FISHERIES AND OCEANS CANADA

Final Submission

Baffinland Iron Mines Corporation
Mary River “Phase 2 Development” Project Proposal

Submitted to: Nunavut Impact Review Board

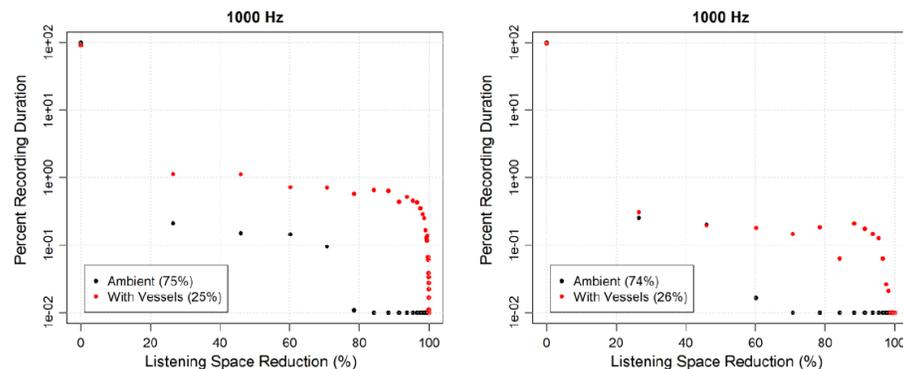
As noted in the summary above, Baffinland provides calculations for Listening Space Reduction (LSR) in Milne Inlet for ambient noise. In the calculation for LSR provided by Baffinland, NL_2 is the sound pressure level with the masking noise present, NL_1 is the sound pressure level without the masking present. DFO assumes that NL_1 is equal to ambient noise and therefore, by definition, LSR for ambient noise should be 0. Secondly, in the description of Equation 1, the memo specifies that the equation used here is a modification of Equation 7 from Pine et al. (2018). Baffinland does not provide justification for any of the modifications; therefore it is not clear why the factor 2, or the negative sign in front of it, was removed from the original equation (Pine et al. 2018). DFO also requires an example of how LSR is calculated. Specifically, it is not clear if Baffinland calculated the LSR or the LRR. As an overarching comment, Equation 1 assumes an isotropic noise propagation and that noise propagation is not constrained (NRC 2003, Gervaise et al. 2012). DFO is concerned that the location of the two listening stations (AMAR-1 and AMAR-3) for which the LSR was calculated is in Koluktoo Bay. Sound propagation is likely to be non-isotropic and limited by land in Koluktoo Bay. DFO is unclear if sound propagation in Koluktoo Bay is isotropic and non-limited by land. If it is not the case, DFO notes that Baffinland should provide comments on the impact of the violation of the assumptions of the equation. DFO is concerned that the violation of the assumptions might result in an underestimate of the listening space reduction.

DFO further notes that the LSR performed by JASCO in the May 2019 'Technical Memorandum: Listening Space Reduction Analysis at 1kHz for 2018 Acoustic Monitoring Data' is based on the current noise from the shipping traffic recorded in 2018. DFO notes that Baffinland is proposing to increase shipping to 420 annual transits in Milne Inlet (Baffinland Information Response, Appendix 12, p. 4-5). Given the significant increase in shipping traffic expected with Phase 2, DFO notes that it would be more appropriate to conduct a modelling exercise to calculate the LSR associated with the increased transits. Additionally, in order to properly assess the LSR, Baffinland should conduct similar modelling in other parts of the Regional Study Area including Milne Inlet and Eclipse Sound. DFO notes that additional information is required for DFO to adequately review Baffinland's assessment.

Further, DFO is unclear as to why Baffinland has "*set to the nominal value of $N=15$* " (May 2019 Technical Memorandum, pg. 1) Baffinland does not provide justification or reference as to why $N = 15$ was chosen. DFO notes that this value will ultimately influence the calculation of the LSR.

<p>Recommendation / Request</p>	<p>Recommendation 3.7:</p> <p>DFO is concerned that the Baffinland provided acoustic modelling does not fully allow DFO to assess cumulative sound level and the assessment of the effect of the sound on marine mammals.</p> <p>DFO-FFHPP recommends that Baffinland:</p> <p>3.7.1 Clarify on how NL1 was calculated and on how LSR was calculated for ambient noise, providing rationale for the modifications to the equation from Pine et al. (2018), and providing an example of how LSR is calculated.</p>

<p>3.7.2 Conduct a modelling exercise to calculate the LSR associated with the proposed increased transits. Including modelling in other parts of the Regional Study Area including Milne Inlet and Eclipse Sound.</p> <p>3.7.3 Provide new calculations based on the new guidelines (Southall et al. 2019) or provide comments on the difference in methods and results between the older and newer methods, as well as consider temporary threshold shift (TTS) and not just permanent threshold shift (PTS), where relevant.</p> <p>3.7.4 Provide long term monitoring plan to verify the prediction of the sound propagation modelling and its potential effects on the populations of marine mammals.</p>
--	---
